DELAWARE RIVER AND BAY AUTHORITY

WILMINGTON AIRPORT

ADDENDUM NO. 1

DEPARTURE LOUNGE CONCESSION AREA

C-A-571R1

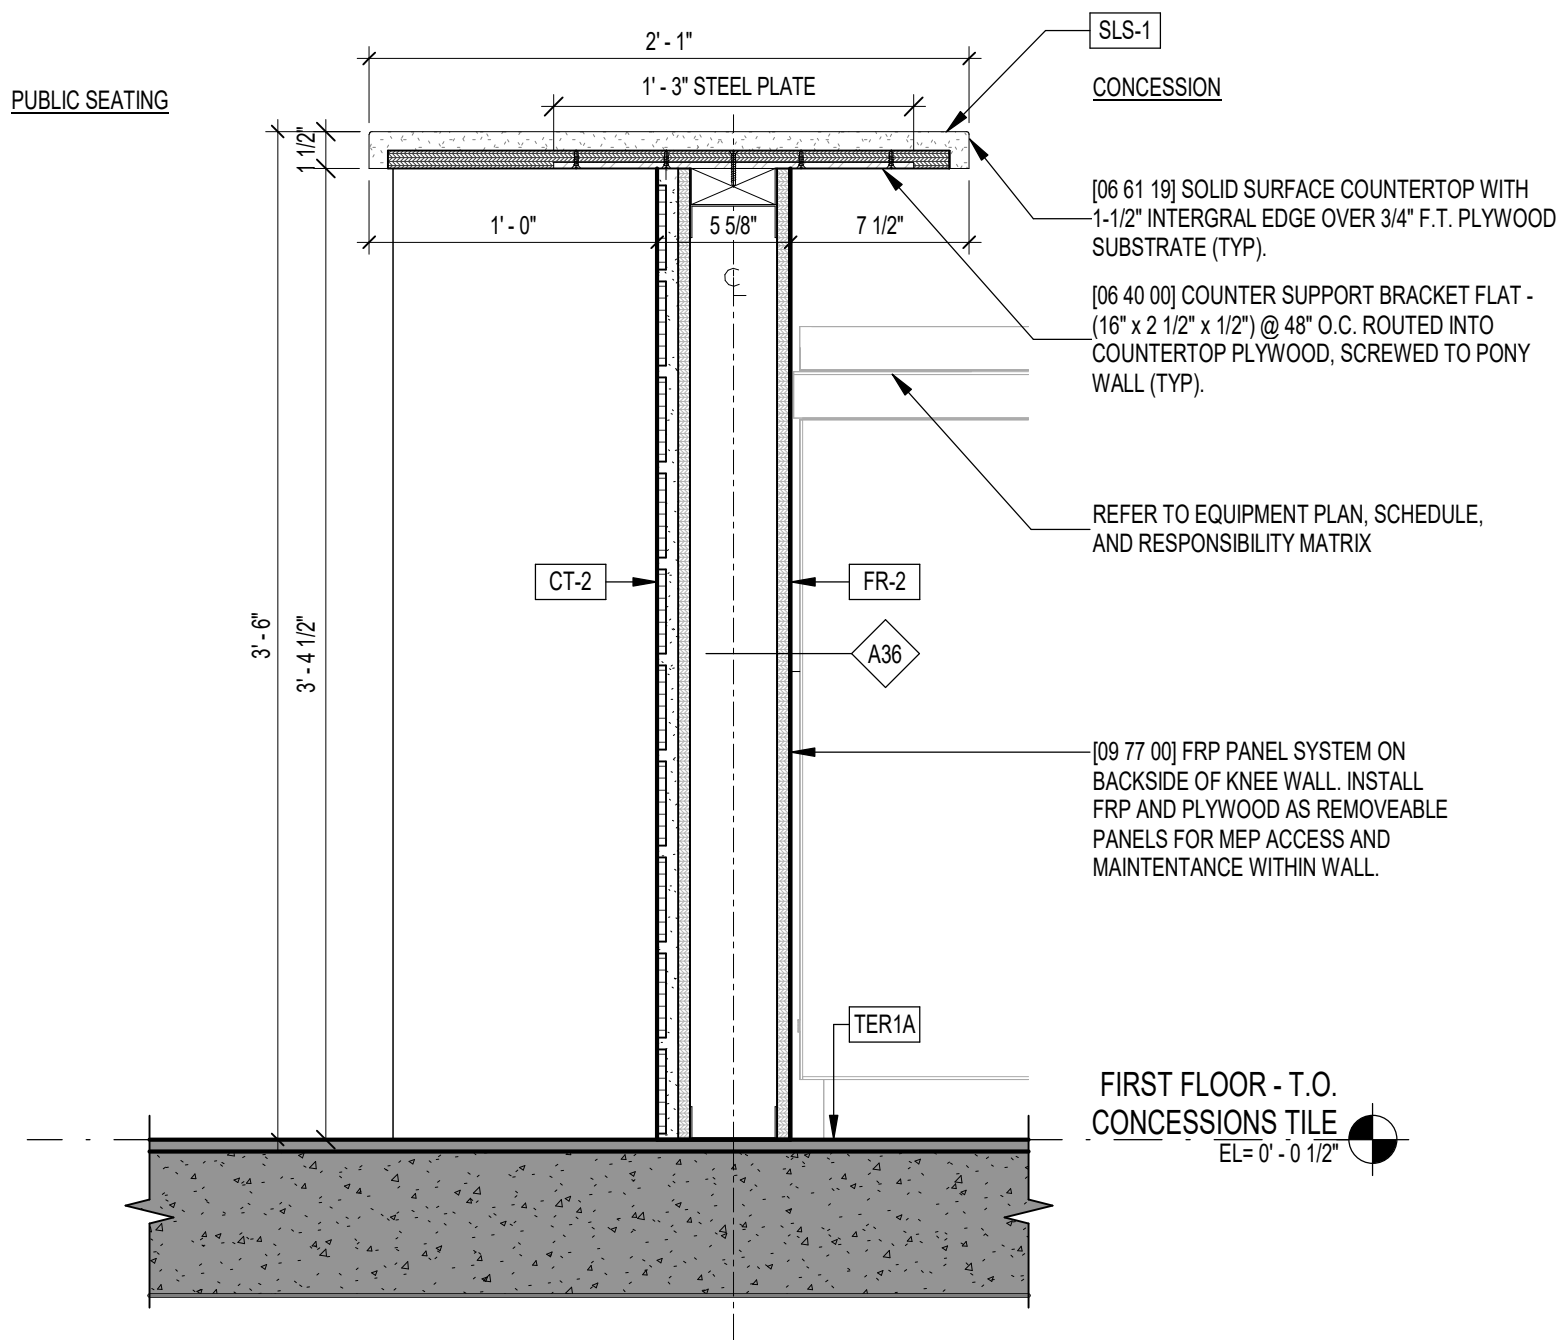
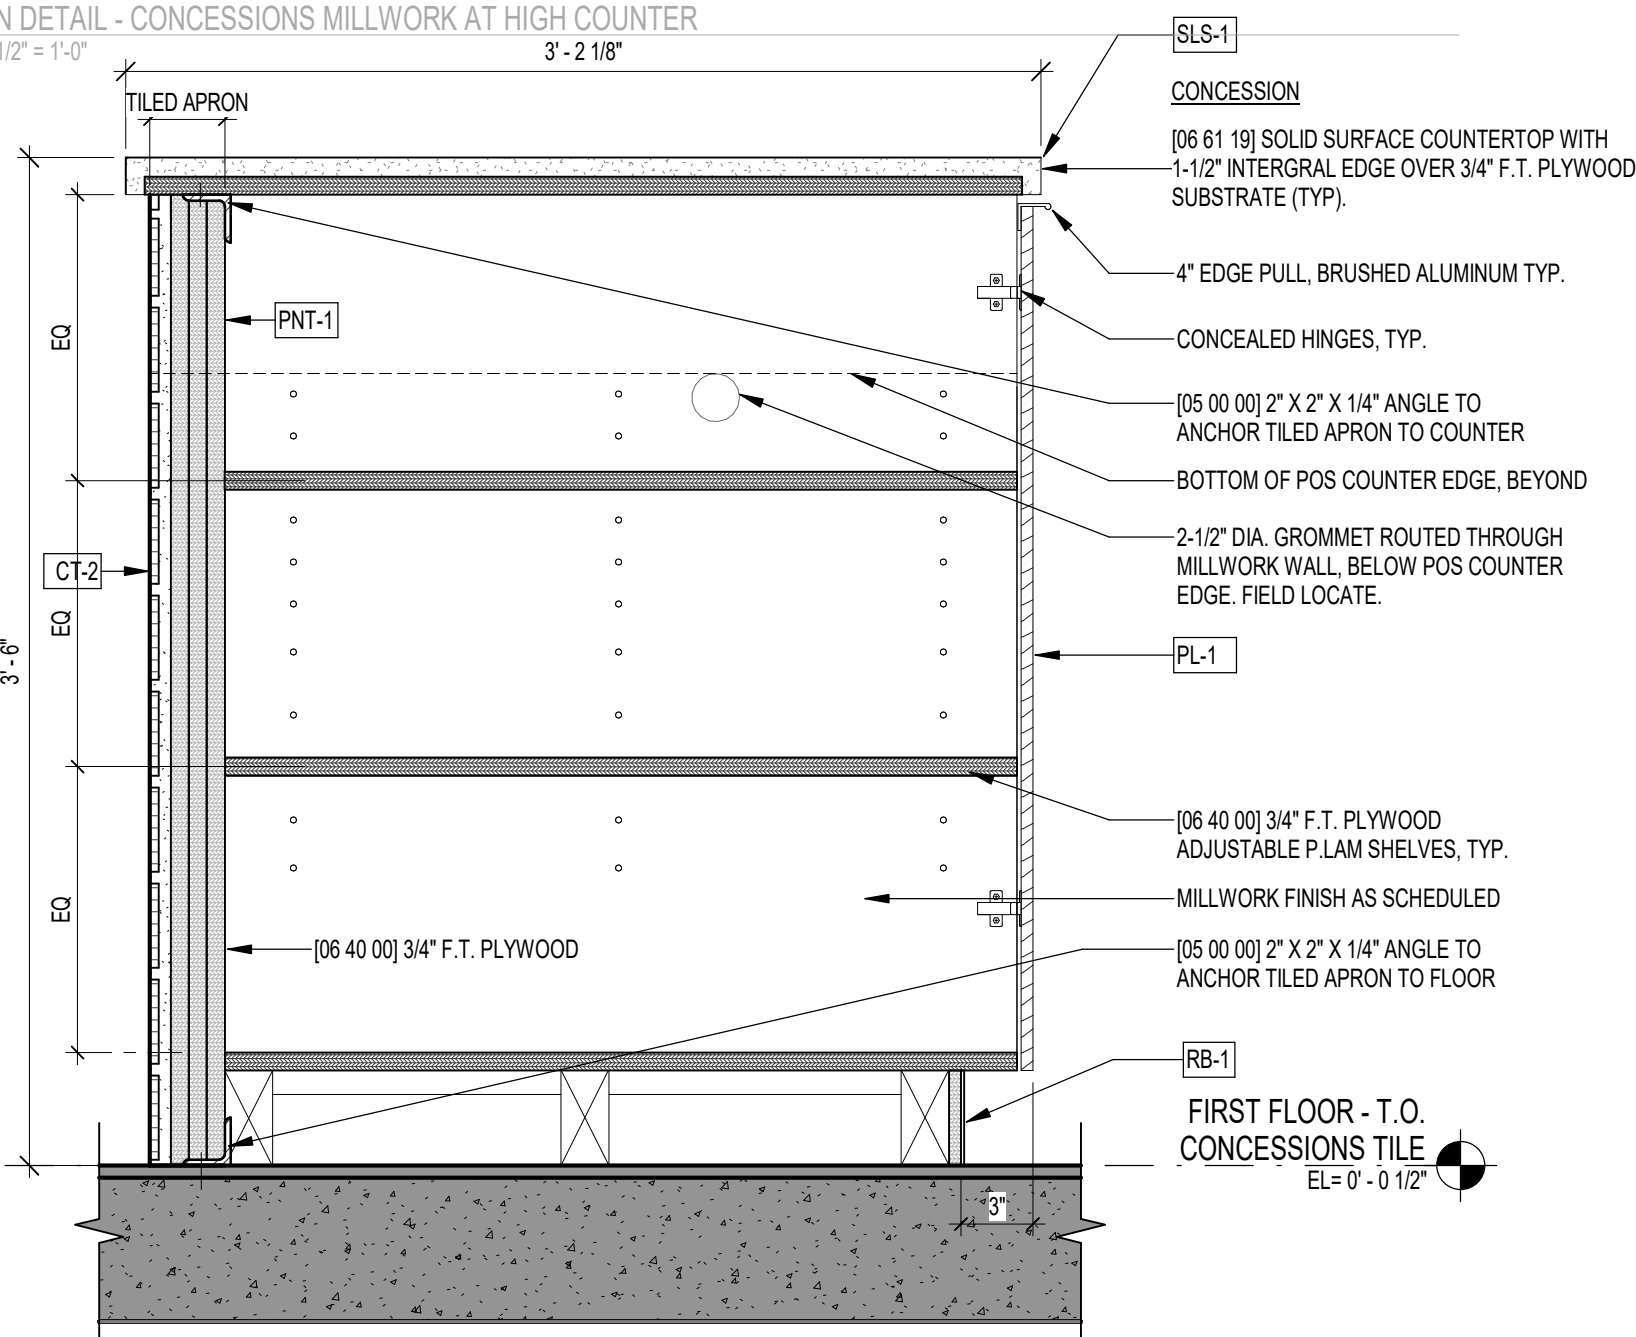
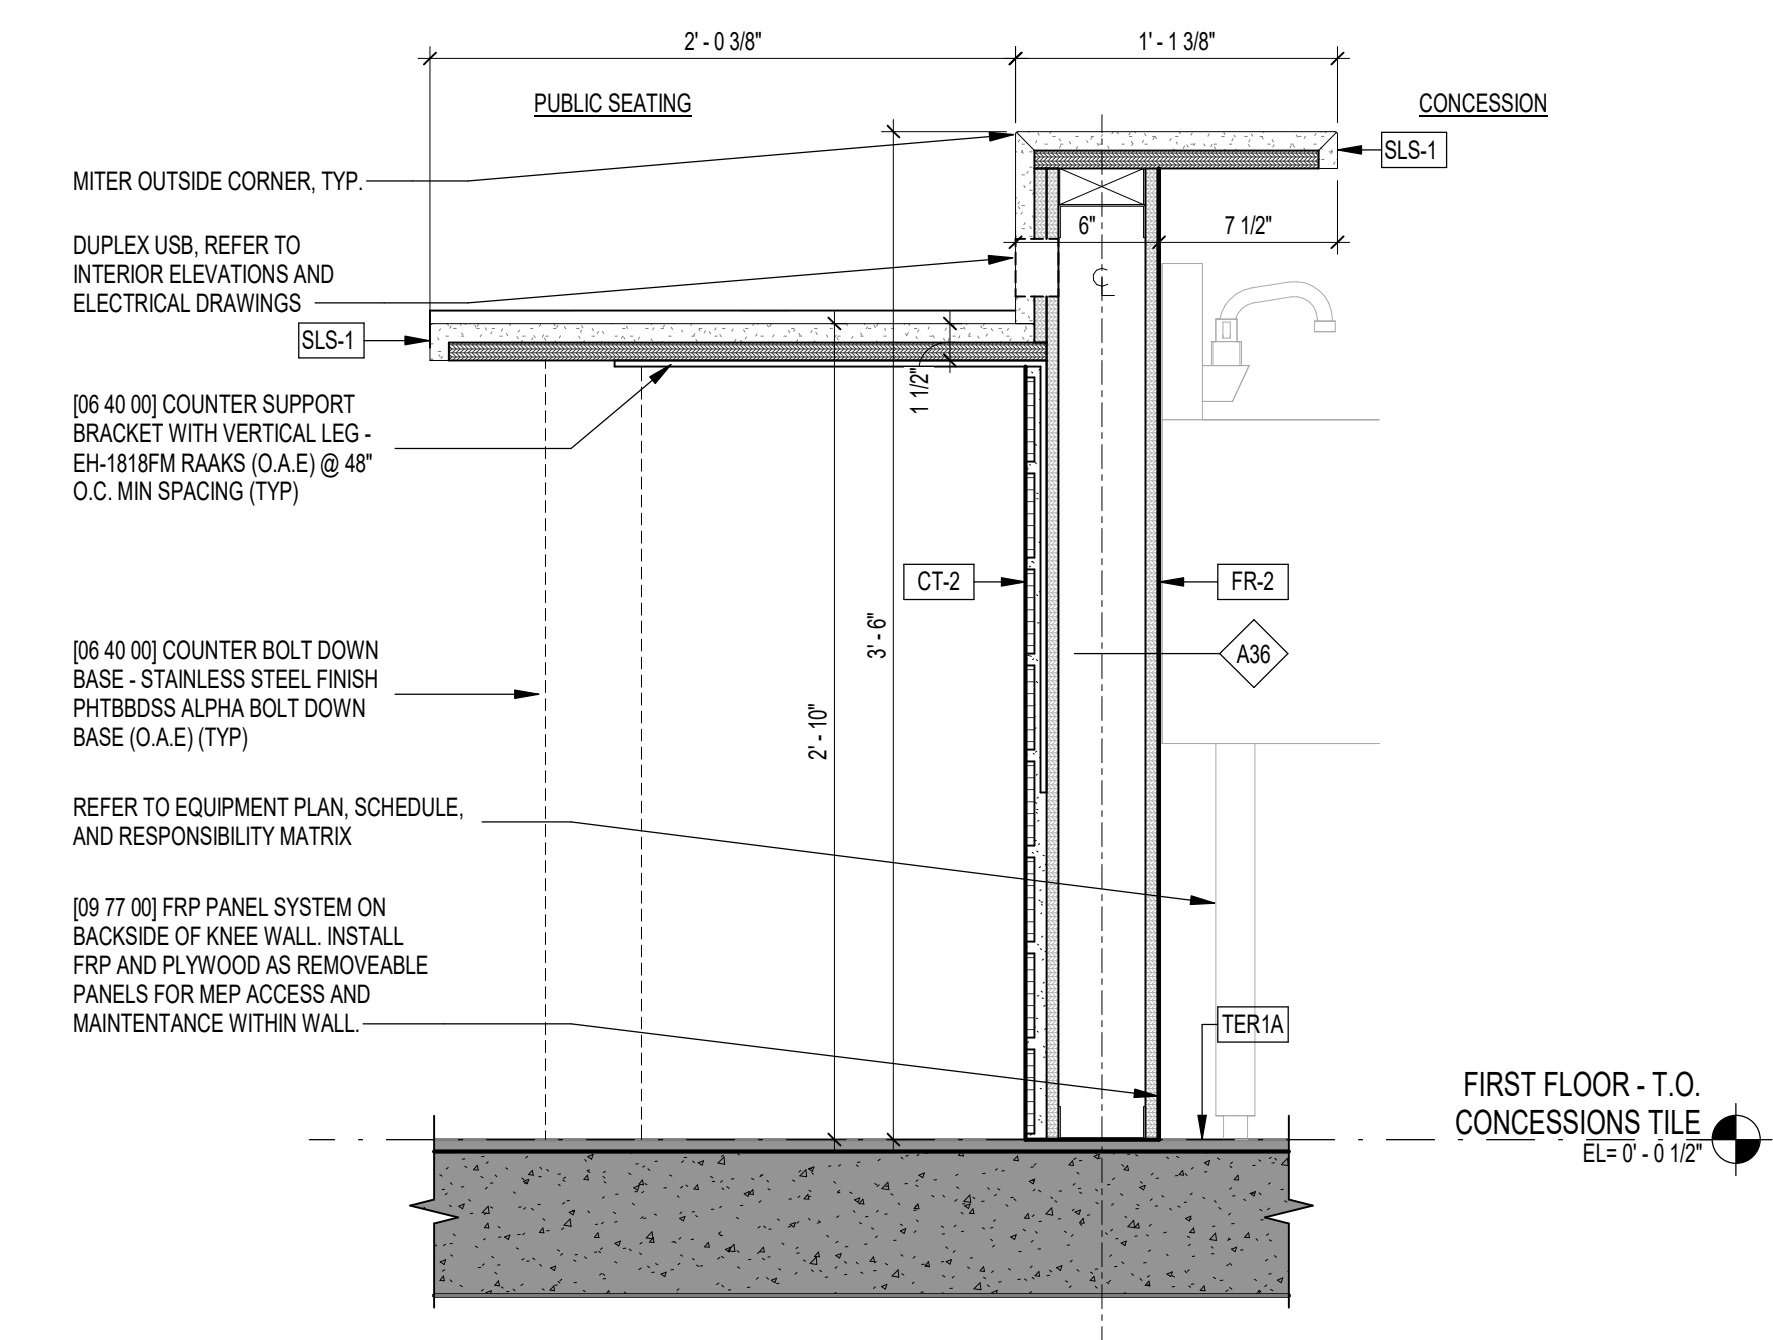
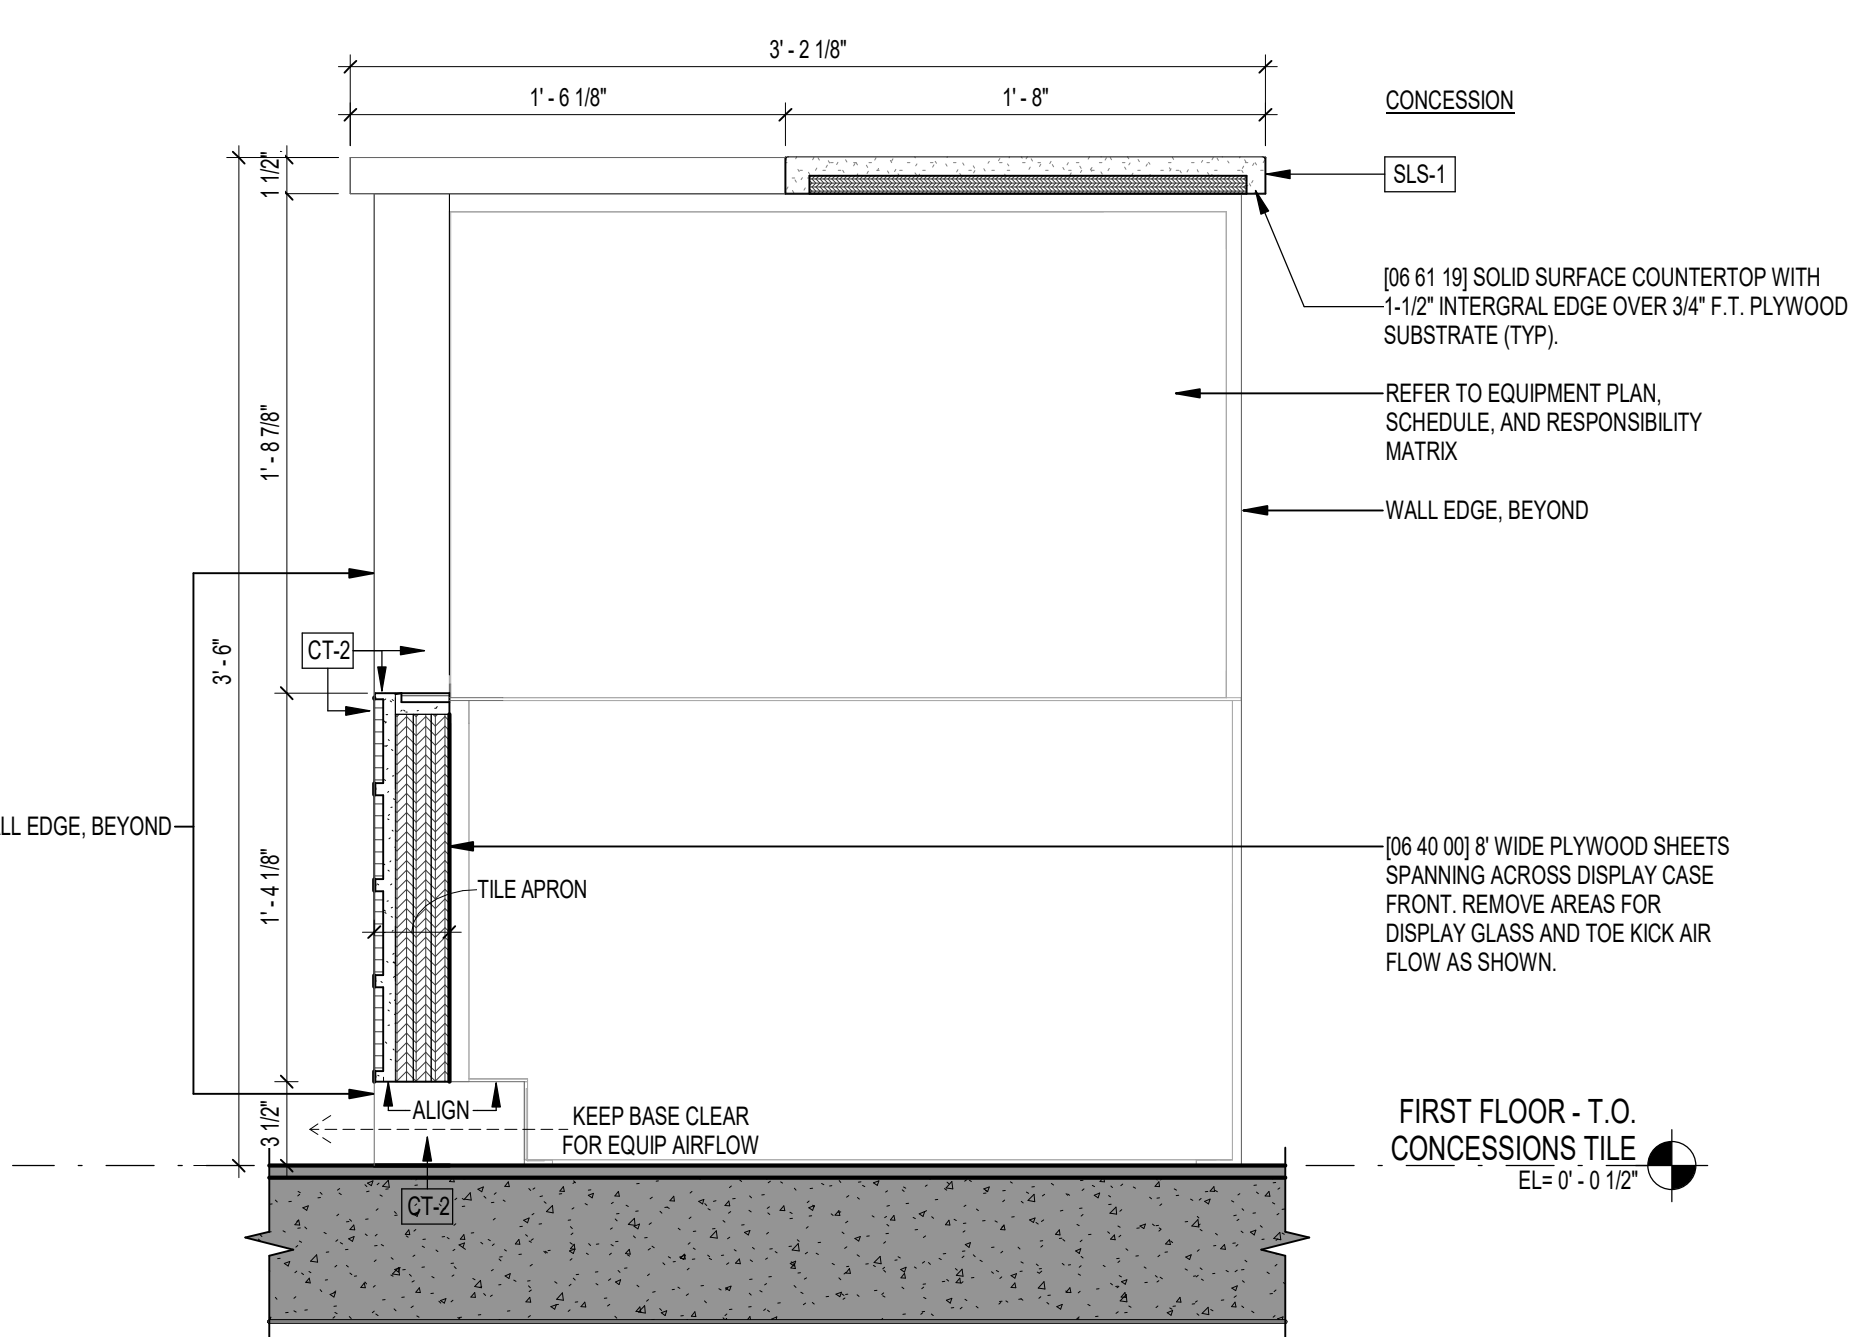
- Q6. Plan Sheet A-571 Finish Schedule calls for SLS-1 Dupont Corian Designer White. This is ½" thick. All sections on this sheet show material at ¾" in which would be Dupont Quartz Designer White. Do you want Corian or Quartz?

- A6. See Amendment No. 1. Corian; thickness dimensions on Plan Sheet A-571 have been updated.
- Q7. Plan Sheet A-100 has reference tag as #5 but there is not an elevation 5 on any of the plan sheets. We need the elevation 5 to see what you want for millwork under the countertop. Designer White is only available as a solid surface color. DuPont only offers ¾" thick solid surface in glacier white and cameo white, which is non-stock / special order / available in pallet quantities of 7 sheets. The sheet size is ¾" x 30" x 144". Otherwise, Designer White is available in ¼" x 30" x 98" sheet size, but this material is also non-stock / special order / available in pallet quantities of 16 sheets.
